Subject: FW: Submission re developement assessment Lot 07651, Town of Darwin
Attachments: LittleMindilCliff_1.jpg; LittleMindilCliff_2.jpg; LittleMindilCliff_3.jpg; LittleMindilCliff_4.jpg

Comment on a referral for standard assessment submitted by KTT Investment Pty Ltd to develop the Lot 07651, Town of Darwin (25 Gilruth Avenue, The Gardens) into accommodation for tourism, consisting of beachfront and lagoon villas, a hotel, serviced apartments, dining facilities, a market, function centre, bar and recreation facilities.

Comment 25 – Helge Suhr – Attachment

Little Mindil Cliff – 1

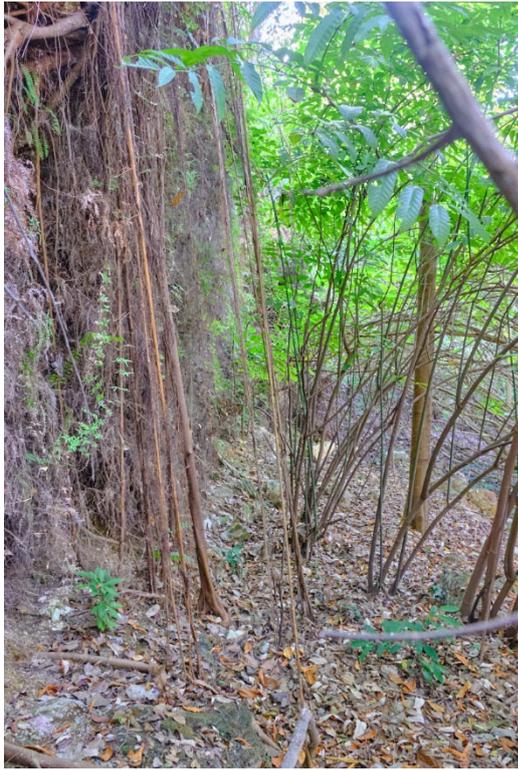
- As owner of a townhouse on top of the cliff (1 Burnett Place) I am particularly concerned about the effect of the development on the cliff stability:
The above ground powerline currently running to the substation will be put underground close to the cliff edge.
A reduced setback to the cliff is sought for the building.
Construction of the buildings will involve use of heavy machinery. The resulting vibration and disturbance of the ground may well destabilise the cliff and threaten the existing buildings on top – 5 townhouses (1 Burnett Place) and Myilli Towers apartment block.
In the building application I can not find any geological assessments looking into this risk.
Please find attached 4 photos: 1-showing the proximity of the townhouses to the cliff top (they have been there for 40 years without any structural issues). 2-Showing the cliff line with its existing green belt that stabilises the cliff base. 3+4-The slope beneath the cliff top that stabilises the cliff base.
